Washington Apartments

2239 WASHINGTON STREET
HOLLYWOOD FL

Reference: Washington Apartments
2239 Washington Street
Hollywood, Florida 33020
TAC #19-DP-76
Architect's Project #19204

The following are our responses to your TAC Comments for the above referenced Project.

P.E.#: 76036
 DATE: 12/30/19
 SCALE: 1"=10'
 SHEET NO.: **C2**
 2 OF 6
 PROJECT NO.: 19-53

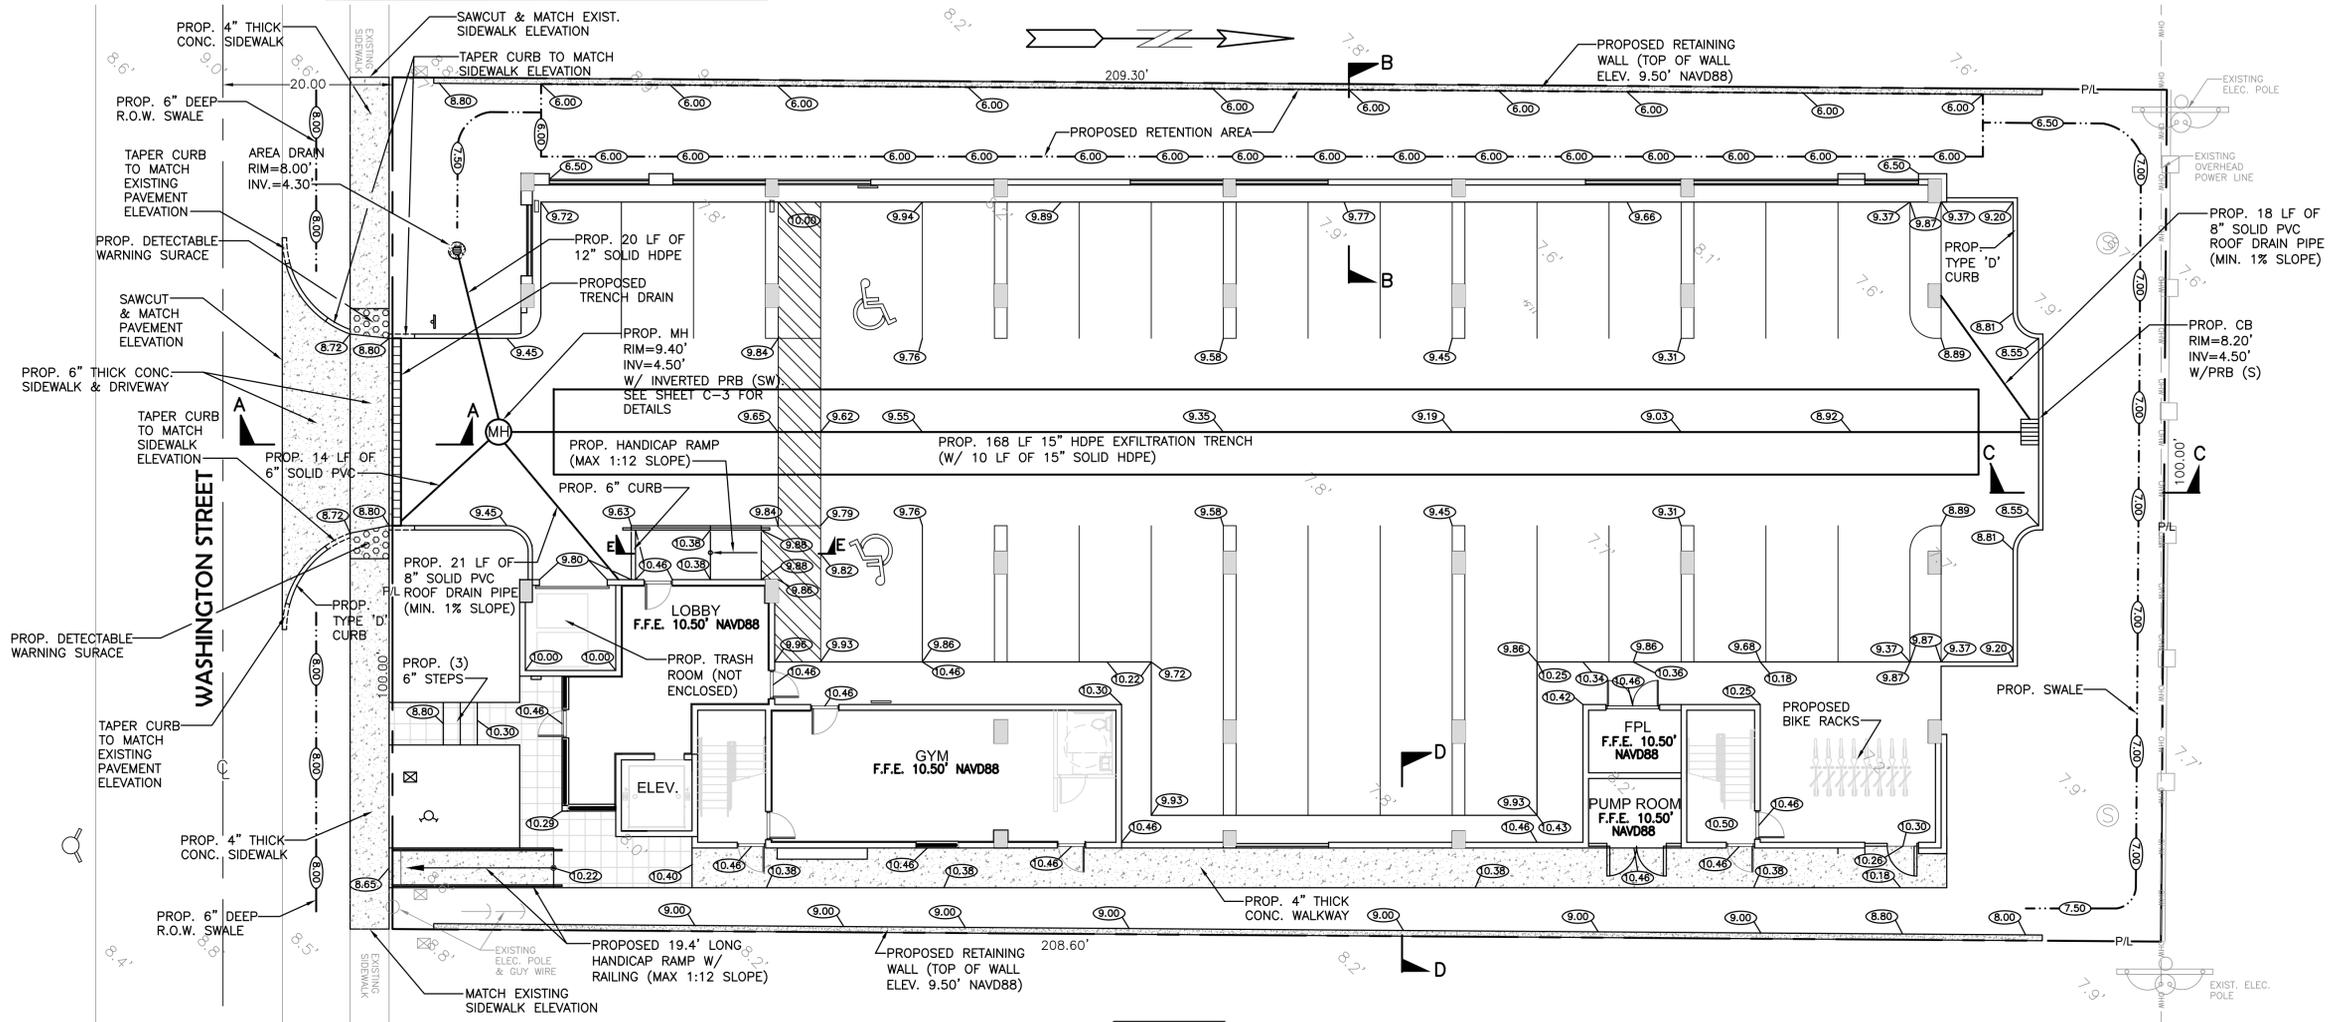
1. Show on plans how ADA accessibility requirements are met. ADA accessible route is required between accessibility parking and building access as well as accessible route to the public rights-of-way.

3. Provide civil engineering streetscape plans and plan details, showing proposed new sidewalk in public and/or project property along Washington Street.

1. No Submit civil engineering plans indicating existing and proposed water, sewer and drainage for initial review.

RESPONSE: Please see sheets C2 and C4 for ADA accessible route.

RESPONSE: Please see proposed sidewalk along Washington Street on sheet C2.

RESPONSE: Please see sheet C2 for finished floor elevation. The highest adjacent crown of road elevation is 9.00' NAVD88. Therefore, the minimum finished floor elevation of enclosed areas is set at 10.50' NAVD88.

3. Verify proposed lobby FFE = 12.50' NAVD 88. No steps indicated.
RESPONSE: The proposed finished floor elevation has been revised to 10.50' NAVD88. Please see sheet C2.
4. Indicate FFE for all enclosed areas on ground floor.
RESPONSE: Please see sheet C2.
5. Show perimeter cross sections including swale transition areas meeting property limits. All stormwater must be retained onsite.
RESPONSE: Please see sheet C2.
6. Indicate how roof drainage will be collected and connected to the on-site drainage system.
RESPONSE: Please see sheet C2.
7. Provide preliminary drainage calculations.
RESPONSE: Please see enclosed drainage calculations.
8. Landscape plans to be provided should coordinate with civil plans to accommodate for drainage features.
RESPONSE: Understood.

P.E.#: 76036
 DATE: 12/30/19
 SCALE: 1"=10'
 SHEET NO.: C4
 4 OF 6
 PROJECT NO.: 19-53

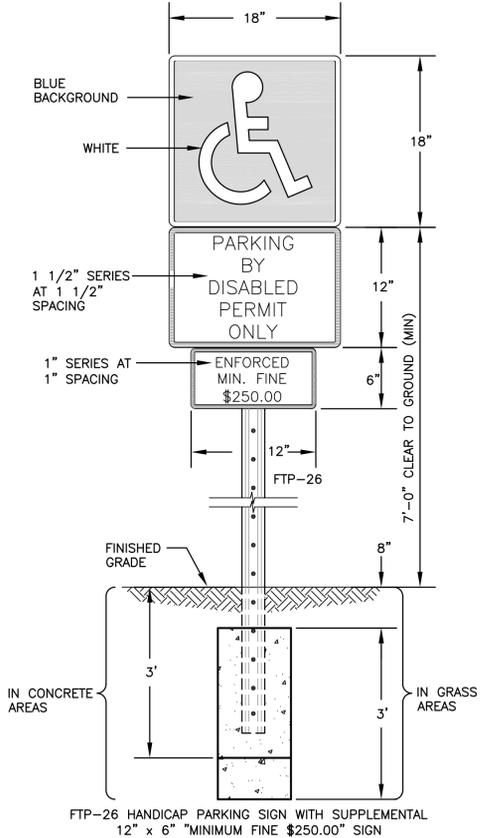
2. For the parking garage, indicate location of building structural columns. Columns shall not be within 3 feet of the entrance of a parking stall. **Dimension shall be added in all locations where you have this condition.**

6. Provide curb ramp with detectable warnings at all accessible crossing. Provide detail for detectable warnings.

RESPONSE: Please see dimensions on sheet C4.

RESPONSE: Please see sheet C4.
